1980 Corvette: Service Bulletin: Rear Wheel Spindle Yoke Snapping Noise

Model and Year: 1980 Corvette

Bulletin No: 80-T-44

Date: June, 1980

FIGURE 1

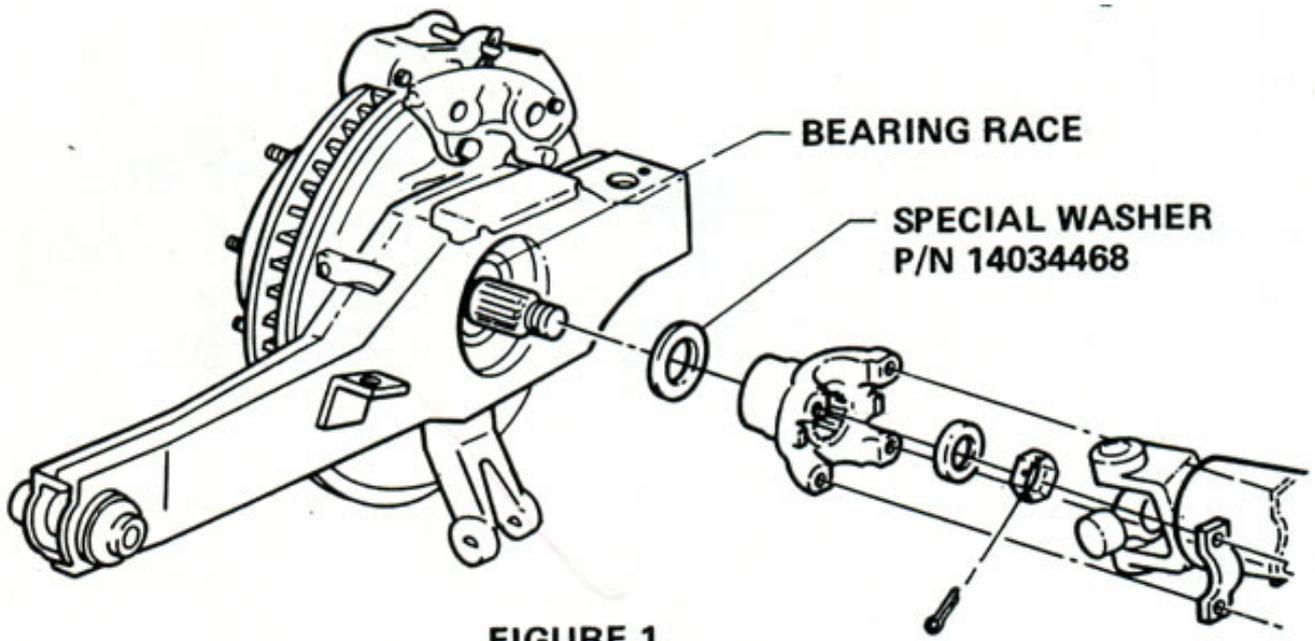
Owners of 1980 Corvettes, primarily those equipped with a manual transmission, may experience a snapping or crunching noise from either or both rear wheel locations during torque reversals and during acceleration or deceleration. This noise is the result of scuffing of the rear wheel spindle yoke against the inner wheel bearing inner race.

This condition can be corrected by installing a special Moly coated washer (P/N 14034468) between the spindle yoke and the inner wheel bearing (see Figure 1). Steps 2 through 8 of the following Service Procedure should be performed at each rear wheel.

FIGURE 2

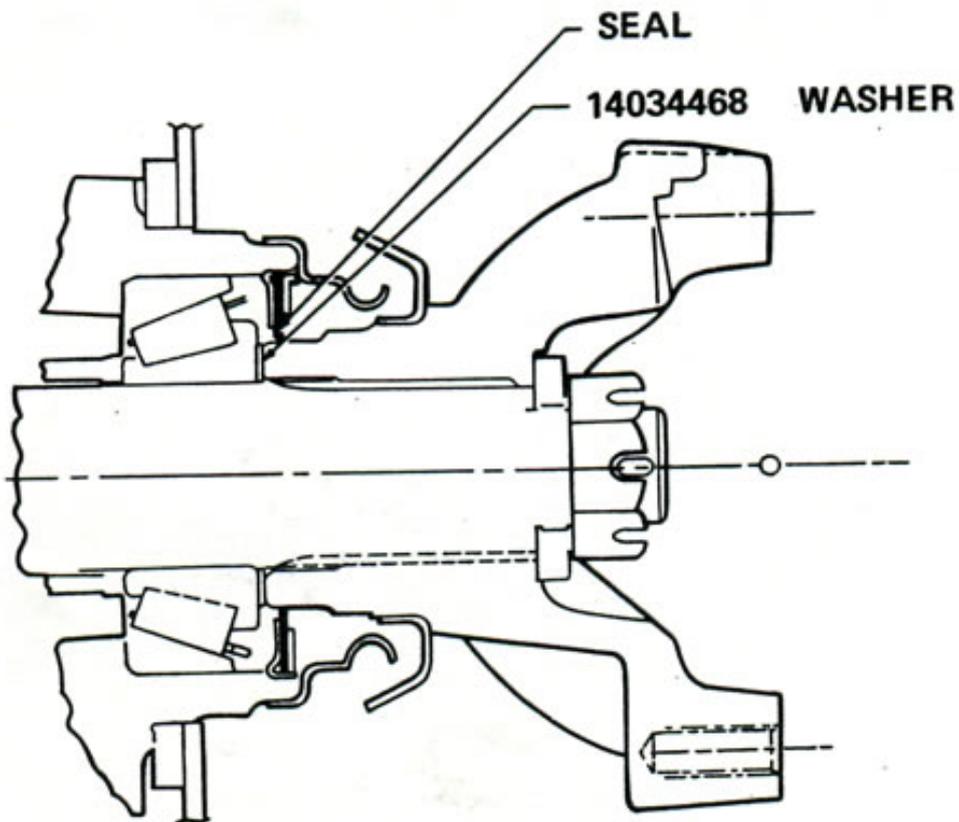
6. Install lubricated washer and spindle yoke on spindle such that washer is between yoke and the inner wheel bearing and completely inside the seal (see Figure 2). NOTE: Use care to avoid nicking the seal lip or trapping it between the washer and the bearing race. If the seal life is damaged, the seal must be replaced.
